Addendum No.: 3

Date of Addendum: June 2, 2020

Willard Diloreto Parking Garage
Paul Manafort Sr. Drive
New Britain, CT
CF – RC – 402

The following clarifications are applicable to drawings and specifications for the project referenced above.

2 STAIR NO. 1 SECTION (E-W)
S106 SCALE: 1/4" = 1'-0"

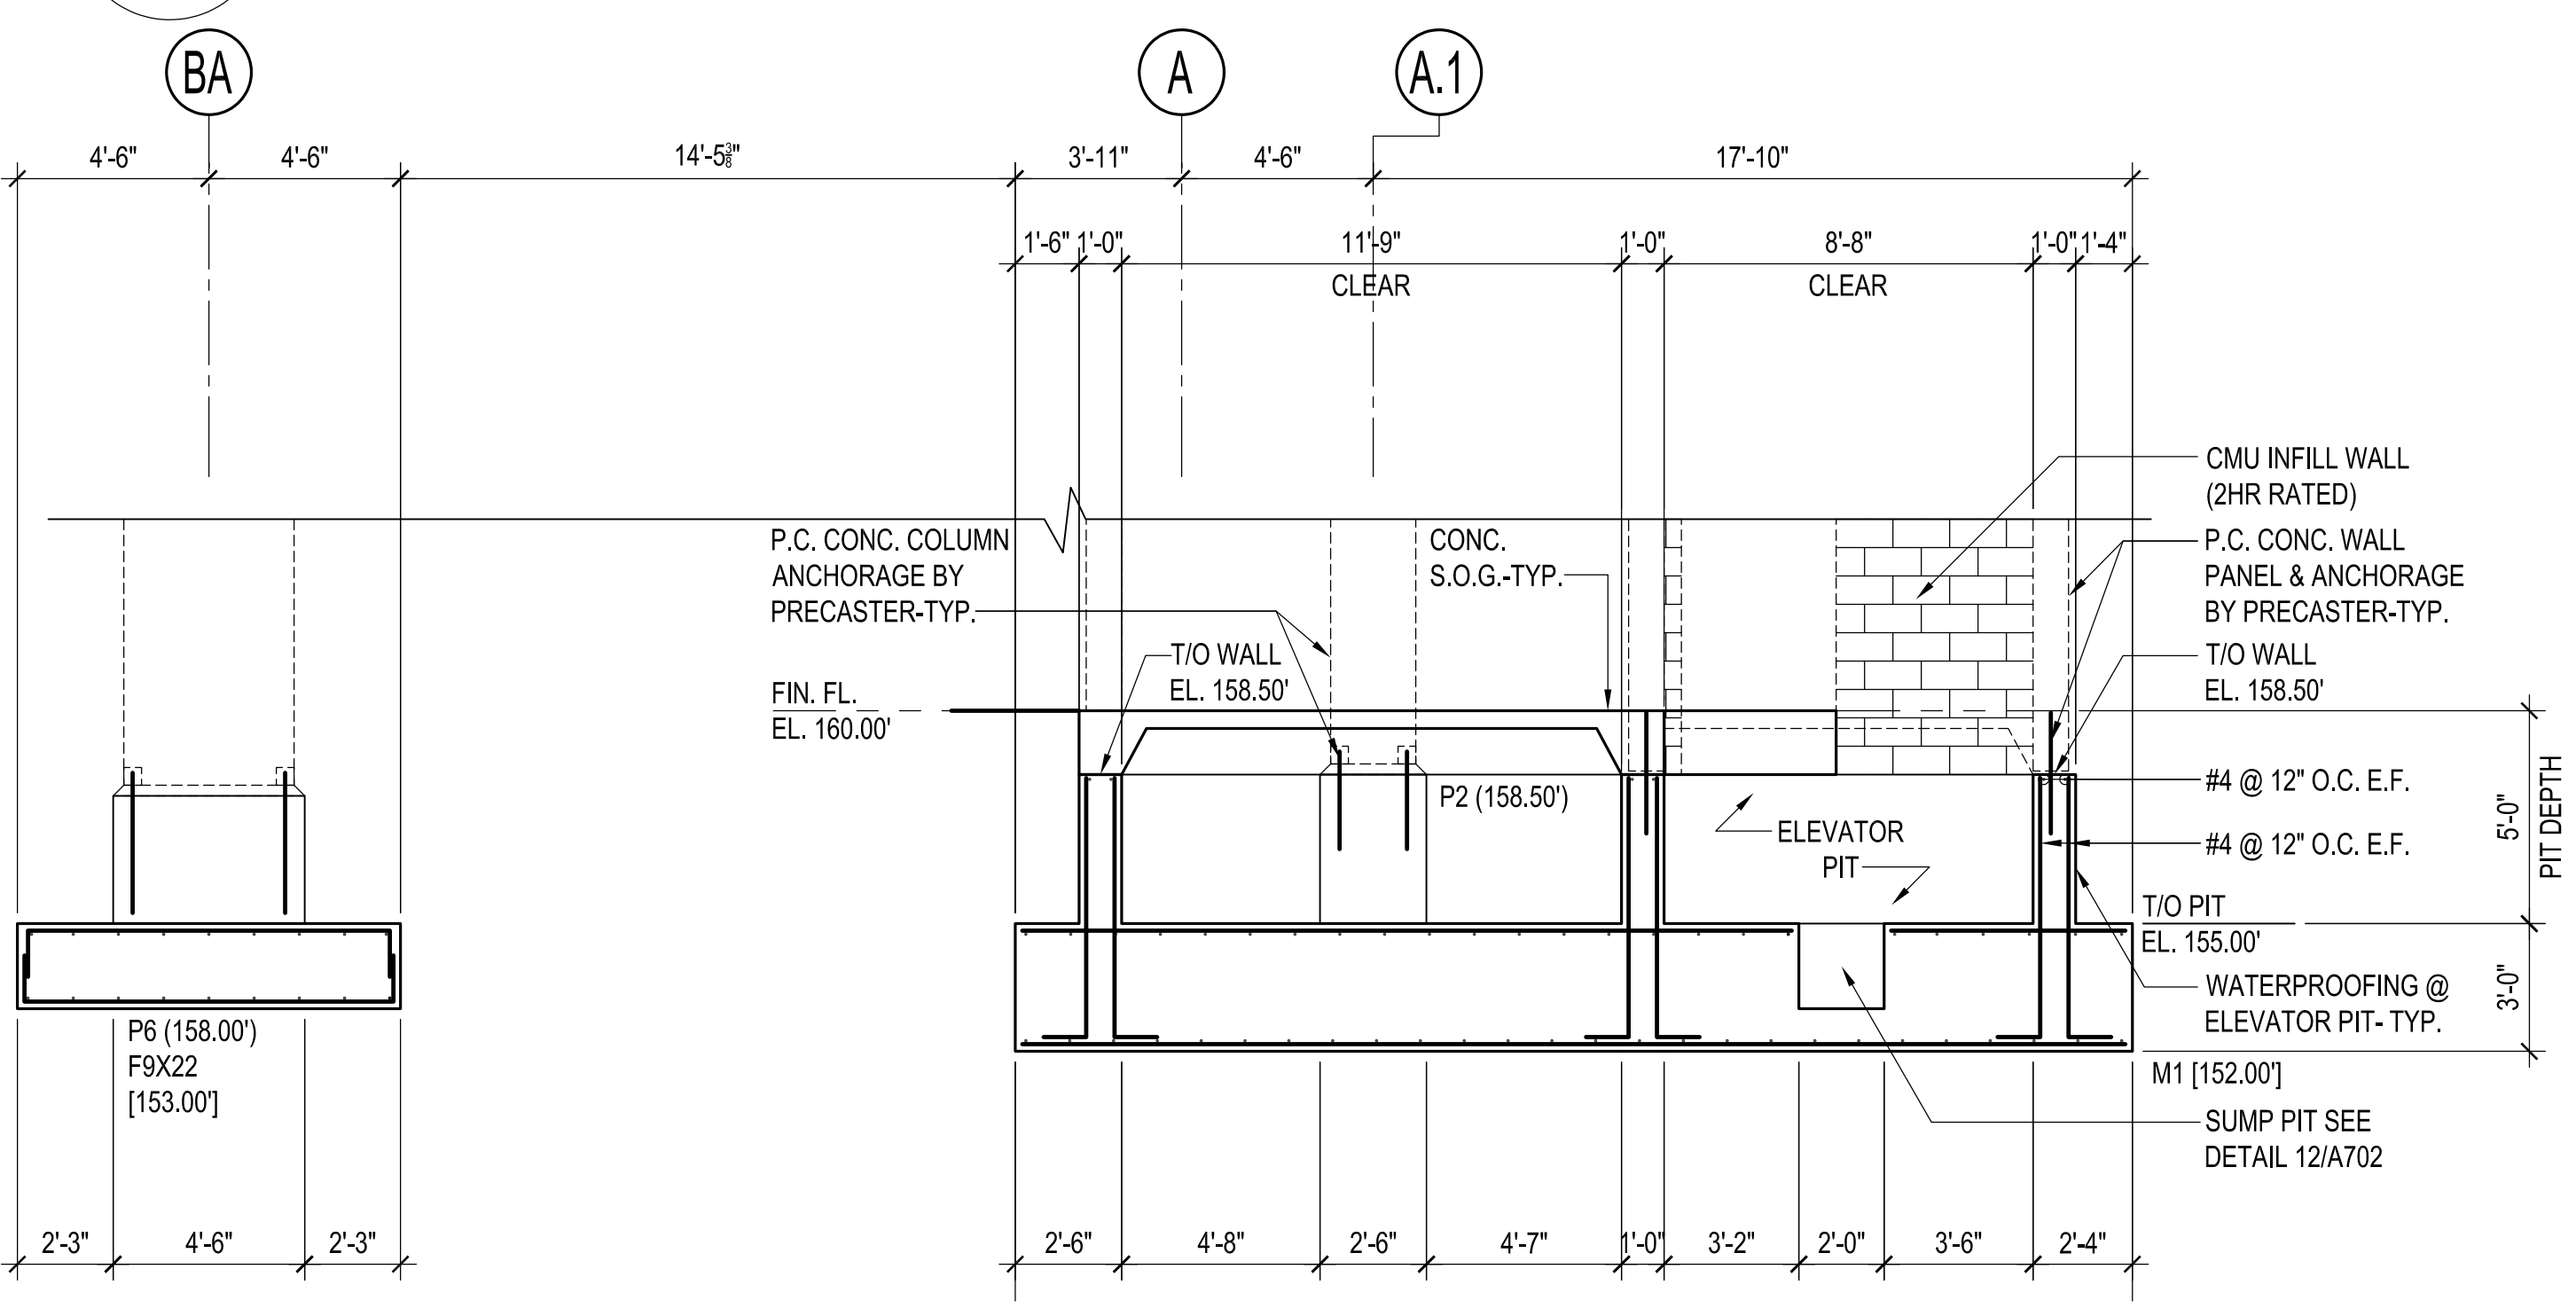
Question: Reference is made to section 1/S107, Along column line 8 just south of column line A.3 there appears to be some type of footing and foundation wall intended to receive bottom of stair 2, we could not find any detail on type, size depth, dimensions?

Answer: See revised drawings S106, S107 and S108. Concrete piers to support the bottom run of the precast stairs have been dimensioned.

1
S108 **STAIR NO.3 FOUNDATION PLAN**
SCALE: 1/4" = 1'-0"

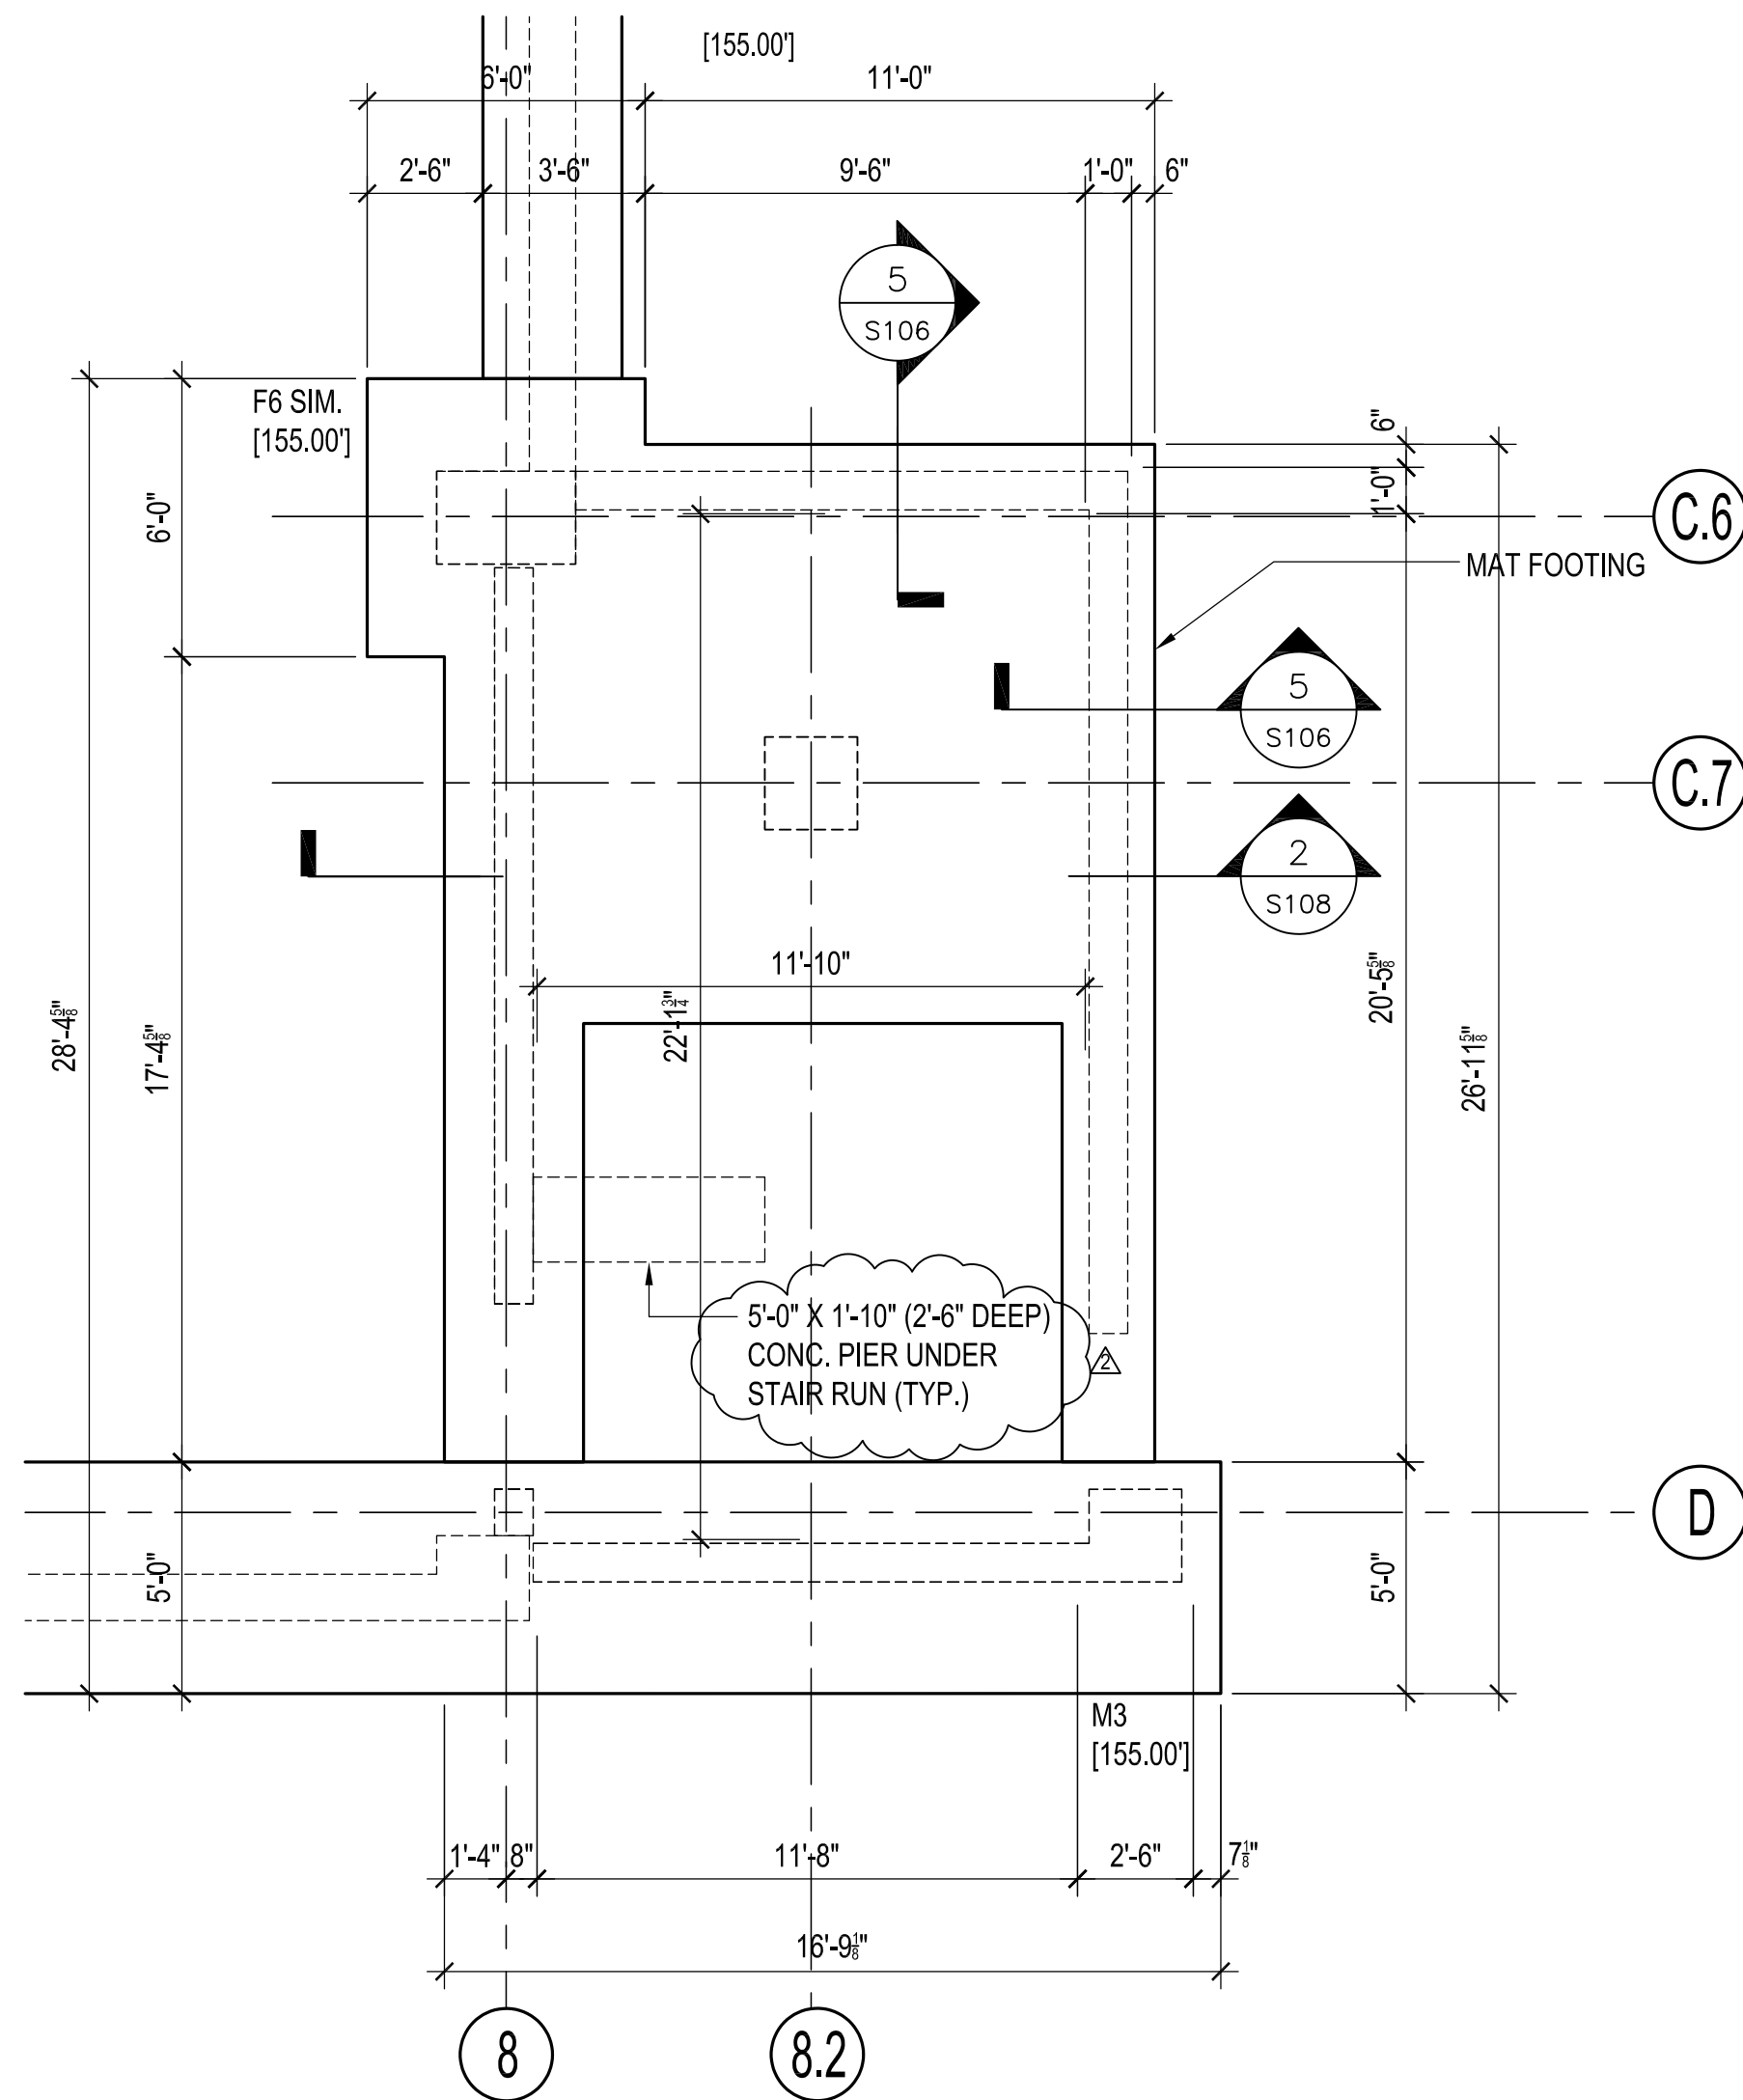
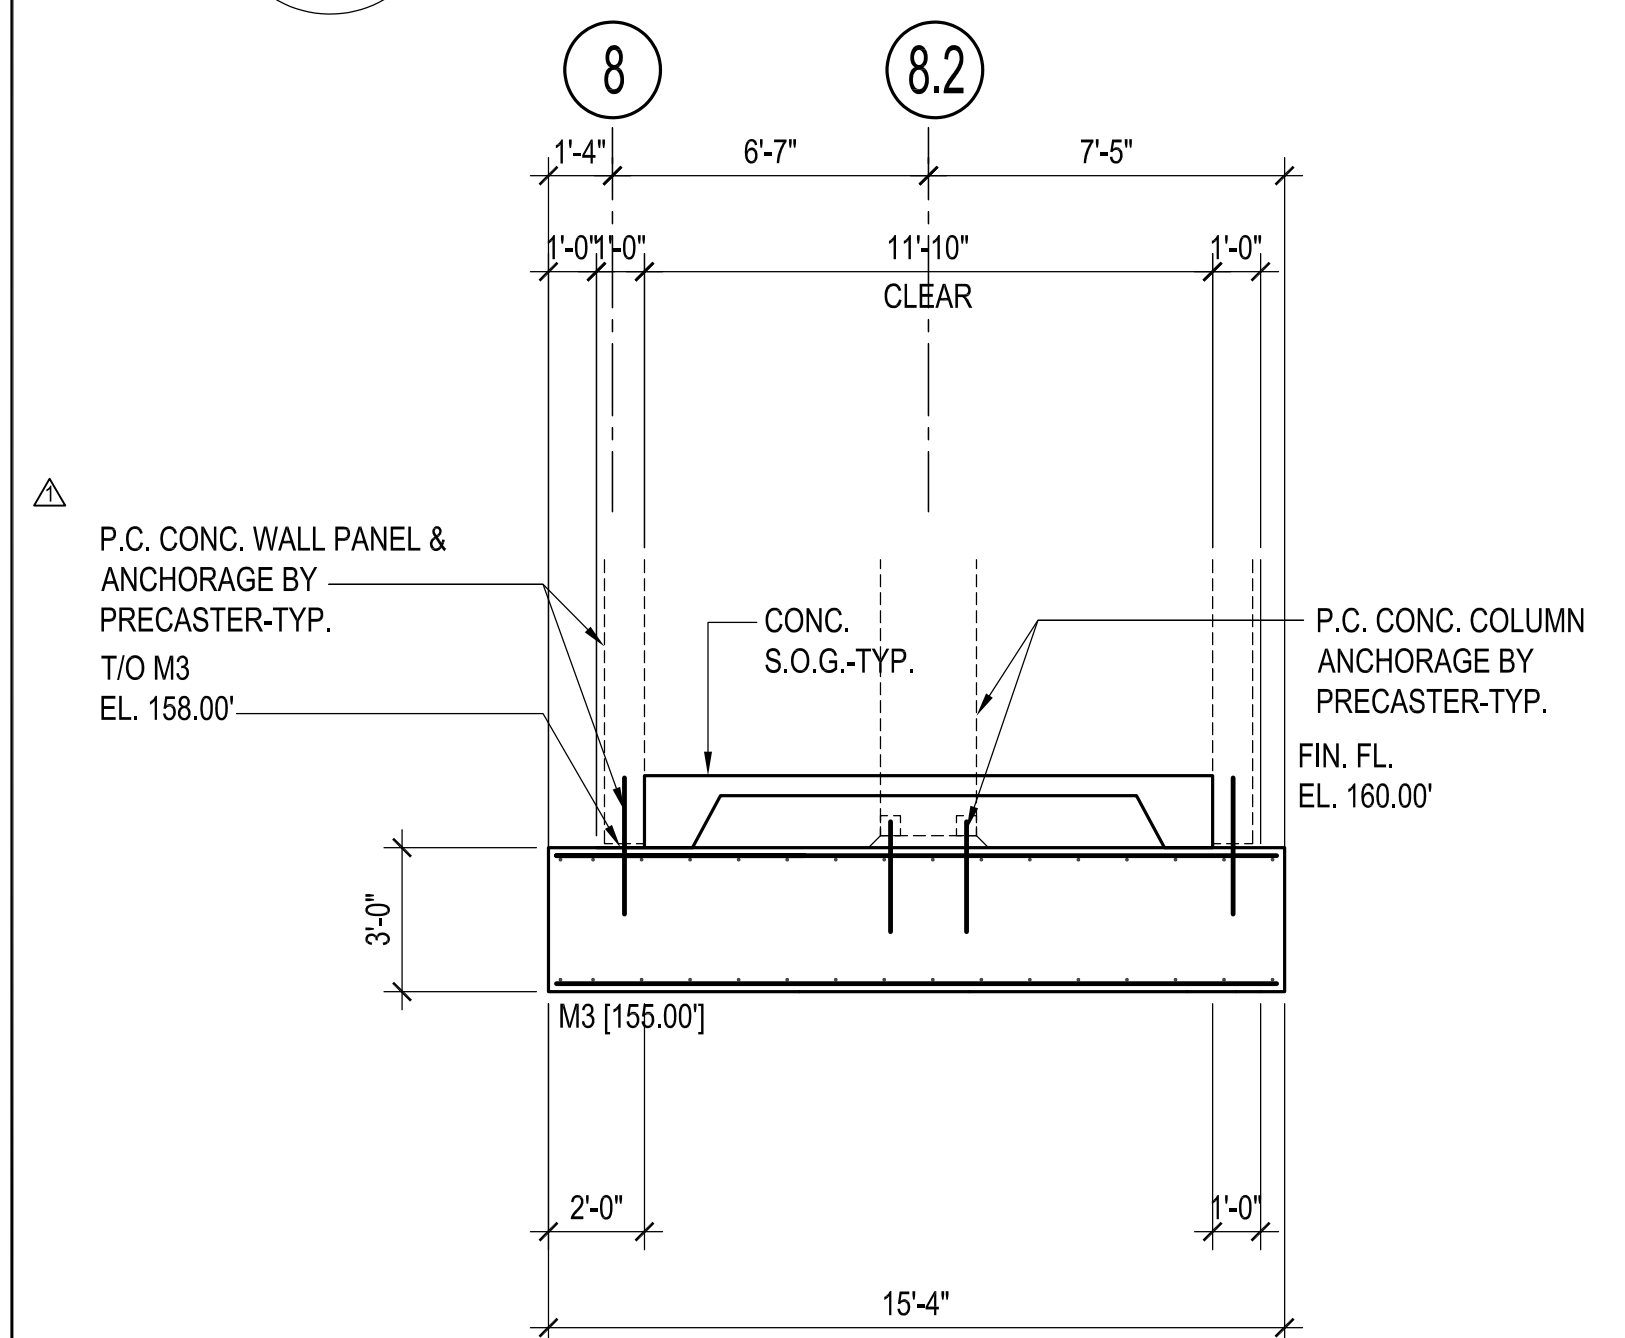
Question: Reference is made to section 1/S108, east of column line 8 just south of column line C.7 there appears to be some type of footing and foundation wall, intended to receive bottom of stair 3, we could not find any detail on type, size depth, dimensions?

Answer: See revised drawings S106, S107 and S108. Concrete piers to support the bottom run of the precast stairs have been dimensioned.
